SERVICE BULLETIN 112

MAINTENANCE PROCEDURE FOR THE TESTING AND REPLACEMENT OF HOOK
AND PILE TAPE USED TO SEAL THE PERIMETER OF THE DEFLATION CAP
IN FLIGHT

AMENDMENT NO. 146

DWG. TITLE
 ENVELOPE, S-50 A

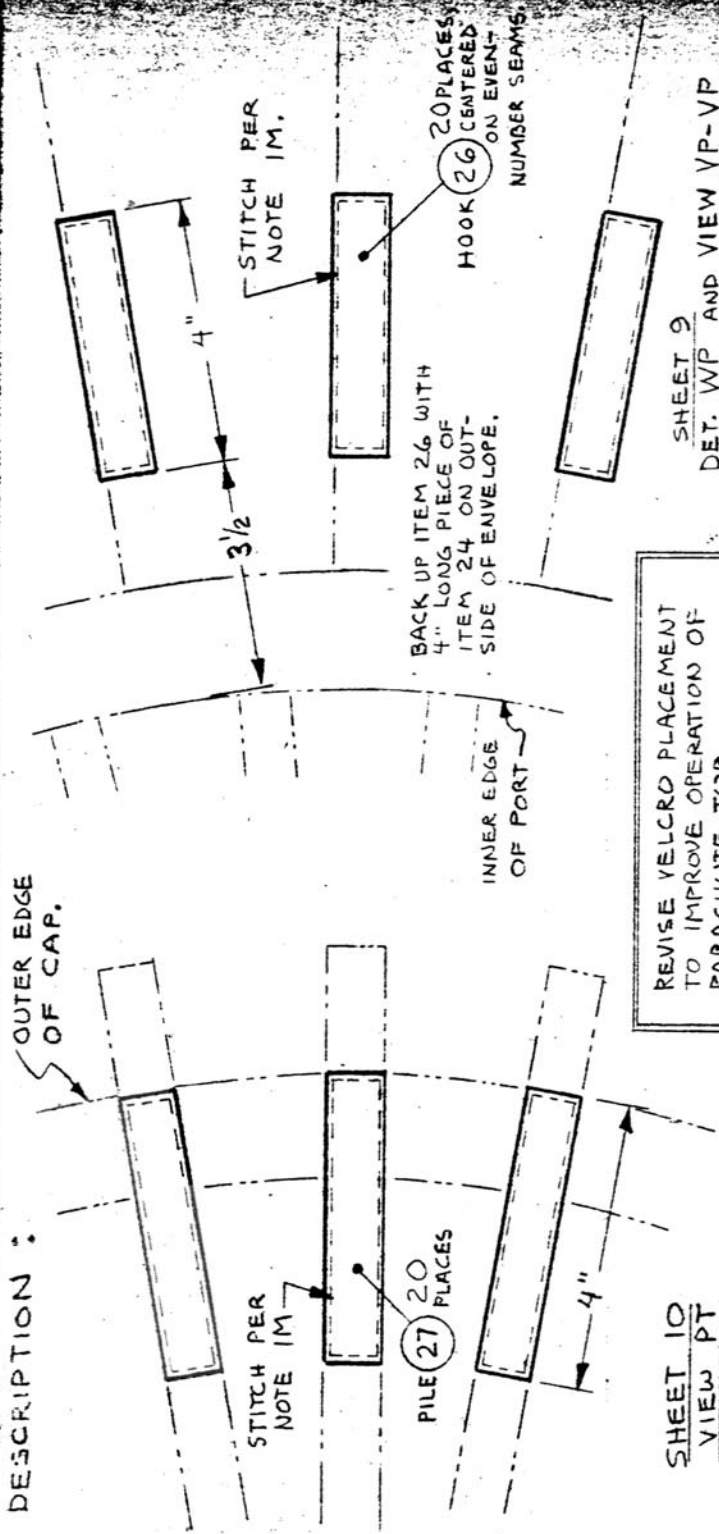
REVISE VELCRO PLACEMENT TO IMPROVE OPERATION OF PARACHUTE TOP
MAJOR CHANGE
 (REF. DR 8604)

CHANGE BASIS (WHY, WHO ETC)
 DR 8604

THIS CHANGE IS OPTIONAL FOR UNITS NOW IN SERVICE
